UNITED STATES PATENT AND TRADEMARK OFFICE

APPLICATION NO.	FILING DATE	FIRST NAMED INVENTOR	ATTORNEY DOCKET NO.	CONFIRMATION NO.
10/647,521	08/25/2003	Gerald Richter	10541-1832	2280
29074	7590	07/17/2006	EXAMINER	
VISTEON C/O BRINKS HOFER GILSON & LIONE PO BOX 10395 CHICAGO, IL 60610			CIRIC, LJILJANA V	
			ART UNIT	PAPER NUMBER
			3753

Office Action Summary

Fig. 1

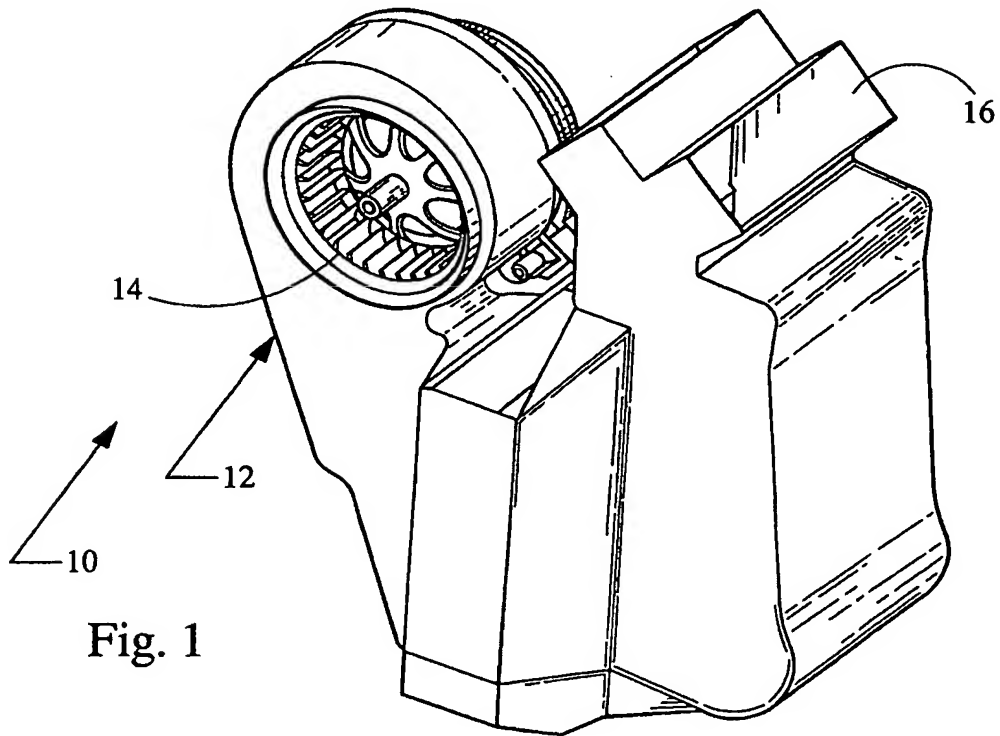
Applicant argues that, unlike the separation wall of the instant claimed invention as recited in the amended claims, the separation wall of Fehr (air deflector 14) extends away from, and not towards, the output (air discharges 2, 4), and that therefor "Fehr fails to disclose all of the elements in newly amended claim.1". In response to the above argument, the examiner hereby traverses the same by noting that claim 1 as amended recites that the separation wall extends "towards *the output in the space between the evaporator core and the heater core*", but (a) there is no proper antecedent basis in the claims for an *output in the space between the evaporator core and the heater core* and (b) as noted in greater detail below, Fehr *does* show the separation wall or air deflector 14 as extending along the length of the heater core 11 towards an *output in the space between the evaporator core 1 and the heater core 11*, the output in that space being readable on the cold air output to the bypass passage 12 formed at the junction of air flap 13 and the separation wall or fixed air deflector 14 as shown in Figure 1.

Fehr discloses a vehicle temperature system essentially as claimed, including, for example: a housing 25 having an intake opening duct (not shown; see column 6, lines 4-8) and an output opening readable on discharge opening 2 and/or 4 and/or 6; an evaporator core 1; a heater core 11 disposed in the housing 25 downstream from the evaporator core 1; a separation wall or fixed air deflector 14 having a first end and a second end, the first end being attached to a first portion of the heater core 11 as shown in Figure 1 and extending along the length of the heater core 11 in the space between the evaporator core 1 and the heater core 11 as also shown in Figure 1; a blower 20 disposed in the housing 25 upstream from

the evaporator core 1; and, a drain area and corresponding drain hole 15 formed through the housing 25 adjacent to the evaporator core 1 as shown in Figure 1. The evaporator core 1 and the heater core 11 are also disclosed as being in a side by side spatial relationship as recited in claim 3 of the instant application. The separation wall 14 also isolates a cold air portion and a hot air portion of the space between the evaporator core 1 and the heater core 11, with the cold air portion 21 being adjacent to the evaporator core 1 and the hot air portion being adjacent to the heater core 11. The separation wall or air deflector 14 extends along the length of the heater core 11 towards the output in the space between the evaporator core 1 and the heater core 11, the output in that space being readable on the cold air output to the bypass passage 12 formed at the junction of air flap 13 and the separation wall or fixed air deflector 14 as shown in Figure 1. The separation wall or fixed air deflector 14 defines a mixing channel or area (in conjunction with the temperature mixing air flaps 13 and 17 and the housing) for mixing, for example, cold air generated by the evaporator core 1 and hot ambient air drawn into the housing via fan or blower 20.
